RE: Carrollton Manor, Lots 55 and 56, Block 4, B02422588
669 Arleigh Road, Severna Park, MD 21146
TM 31 BLK 4 P 38, R-5 Zoning, Council District 5

NUMBER: 2025-0015-V

CONFIRMATION OF PRE-FILE (2024-0056-P)

ADMINISTRATIVE SITE PLAN

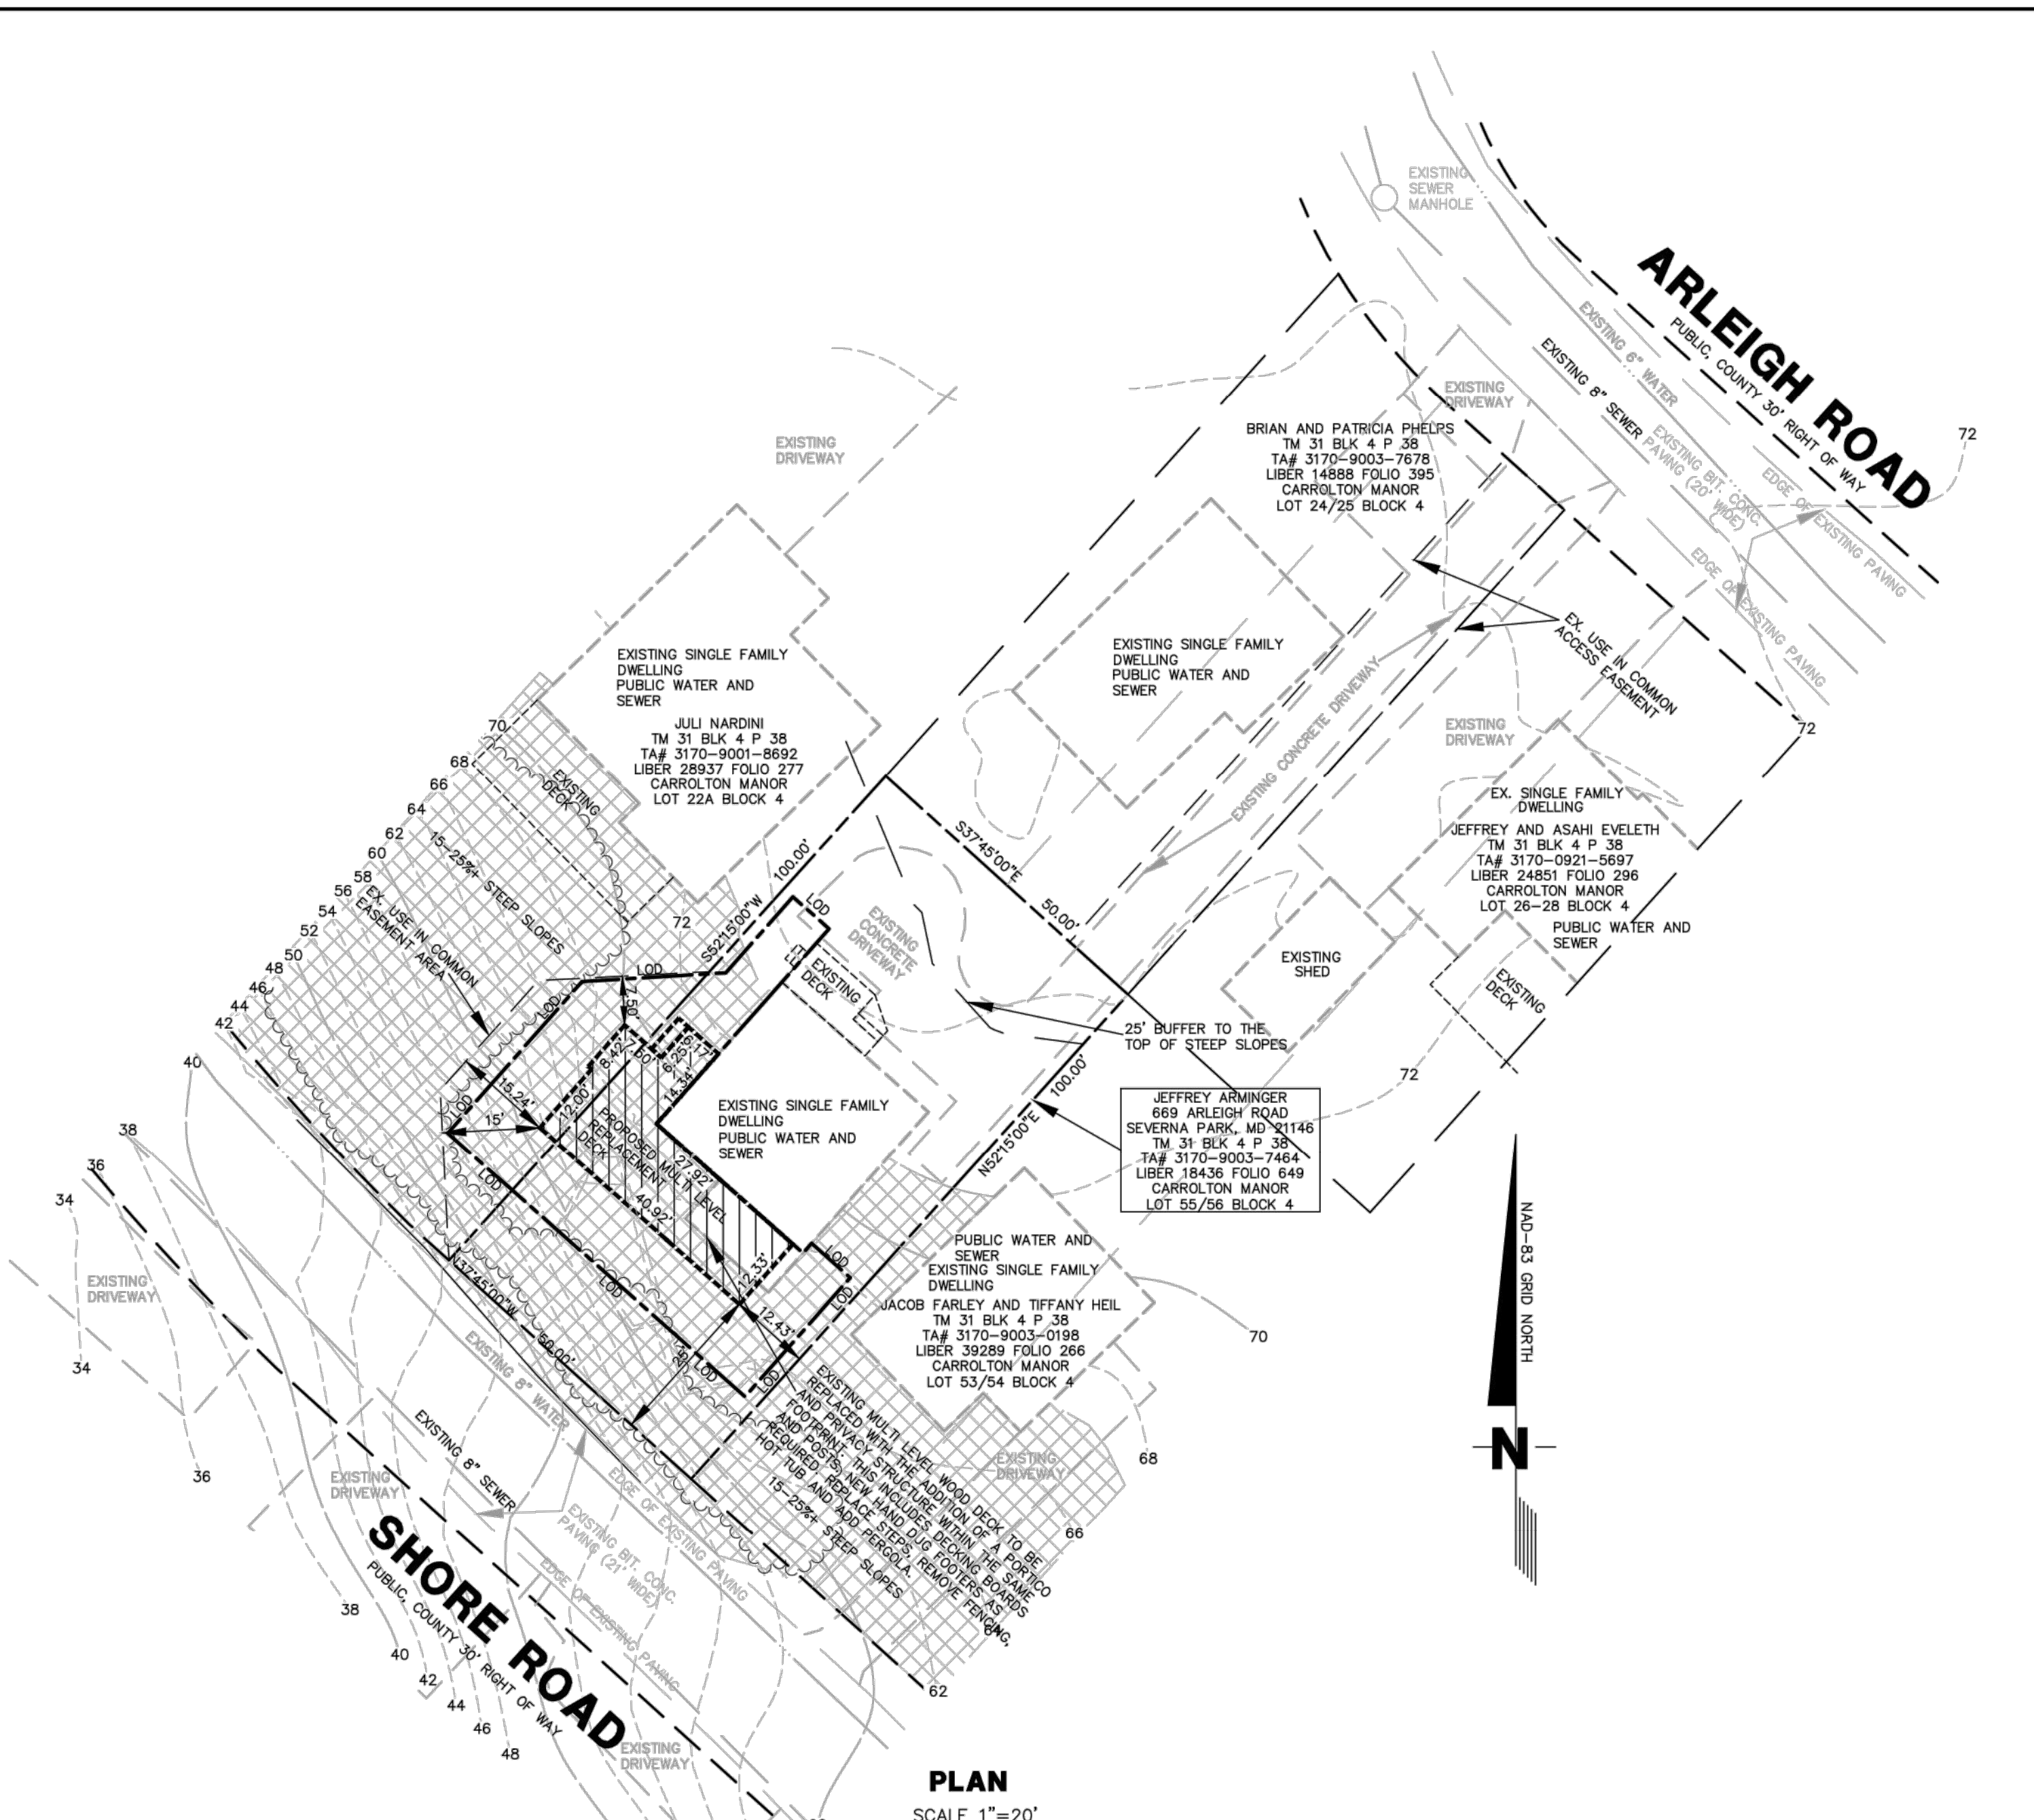
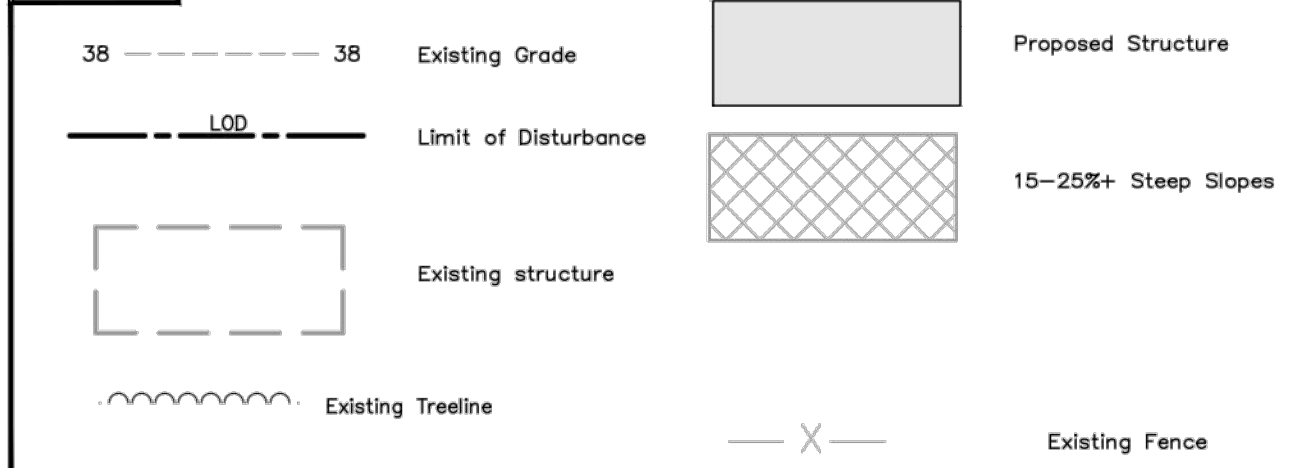
The Critical Area Team reviewed the proposal and has no objection. The Team noted a discrepancy between the actual proposed structures and those described in the leer of explanation. This proposal isn't just a replacement in the same footprint; rather, it is the reconstruction of two levels of deck and the addition of a portico/privacy structure within the same footprint.

The Zoning Administration Section advises the applicant that, per Seccon 17-8-201(b) Development in the IDA, "the Planning and Zoning Officer may grant modification to the prohibition of this subsection for slopes outside of the buffer and buffer modification area." Therefore, a Critical Area Variance is NOT required for this proposal. However, a Modification IS required. Any future applications should clarify the

aforementioned discrepancy by accurately describing the proposed additions in the letter of explanation and associated site plan.

The applicant has not provided any information regarding the “use in common” easement. It is unclear whether the applicant has a right to construct anything within the easement. However, even if they do, the lot line is the lot line. A zoning variance may be required to construct a structure closer than the required seven feet from the actual side lot line. Any future permit application should include clear details of the allowances within the easement area.

Our response: We have revised the description of the proposed work within the variance request.

The variance application has been revised to be only a zoning variance to allow a 0’ side lot line setback.
